Access Compliance Report

Public Rights-of-Way

(Curb Ramps)

Intersection ID: 30136	Main Street: GALESBURG_ST	Cross Street: SIDELL_LN	Location: SW
ADA ID: 5581611C2FC4	Ramp Type: BlendTrans1	Initial Pass/Fail: Pass	Overall Compliance: No
Severity Score: 5			
Codes/Mitigation Info/Possible Solution		Field Measurements/Component Compliance

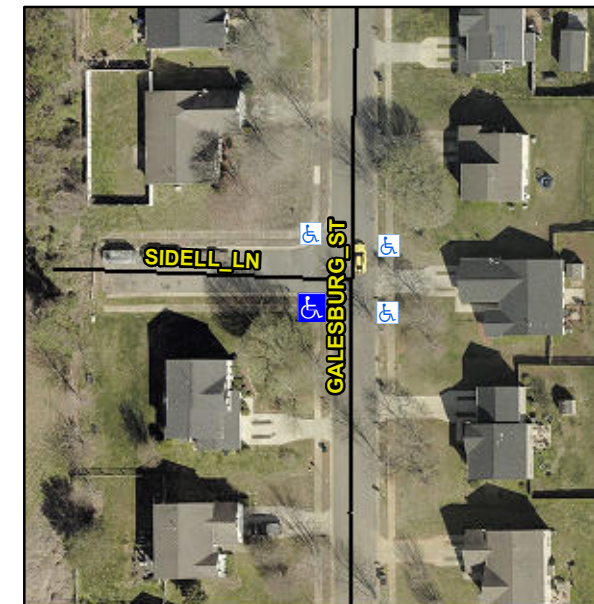
Not Found, R304.2.1, R304.2.2-Perp, R304.3.2-Para, R304.5.3, R305.2, R304.5.4

Compliance	Description	Data	Compliance	Description	Data
N/A	Ramp Length (in)	51.0	Yes	BlendTrans Slope (%)	4.9
Yes	Ramp Width (in)	48.0	Yes	BlendTrans XSlope (%)	1.2
N/A	Flare Type LT	Sloped	N/A	Flare Type RT	Sloped
N/A	Flare Slope LT (%)	2.5	N/A	Flare Slope RT (%)	3.0
N/A	Flare Traversable LT?	No	N/A	Flare Traversable RT?	No
No	Landing Length (in)	45.5	Yes	DWS Provided?	Yes
Yes	Landing Width (in)	76.0	Yes	DWS Contrast?	Yes
No	Landing Slope (%)	2.9	Yes	DWS Length (in)	25.5
No	Landing X Slope (%)	4.4	Yes	DWS Full Width?	Yes
N/A	Landing Curb? (Y/N)	No	No	DWS Offset (in)	3.0
N/A	Shared Landing?	No			
Yes	Gutter Ponding?	No	No	Gutter Slope (%)	6.7
Yes	Gutter Lip Ht (in)	0.0	Yes	Gutter X Slope (%)	0.9
N/A	Painted X Walk1?	No	N/A	Painted X Walk2?	No
	X Walk 1 Direction	To E		X Walk 2 Direction	To N
	X Walk 1 Width (in)	N/A		X Walk 2 Width (in)	N/A
	X Walk 1 Slope (%)	3.0		X Walk 2 Slope (%)	1.4
	X Walk 1 X Slope (%)	1.5		X Walk 2 X Slope (%)	0.3

N/A	Ramp inside XWalk1?	N/A	N/A	Ramp inside XWalk2?	N/A
	Road Slope (%)	1.2		Clear Space?	Yes
	Road X Slope (%)	3.9	N/A	Clear Space to XWalk (in)	N/A
Yes	Any Obstructions?	No	Yes	Storm Grate/Utility Hazard?	No
	Obstruction Type			Storm Grate/Utility Type	
		N/A			N/A
			Yes	Surface Condition? (G/P)	Good
			No	Curb Slope (%)	12.9

Remove & Replace Curb Ramp With Two New Directional Ramps or Equivalent. Remove & Replace Gutter.
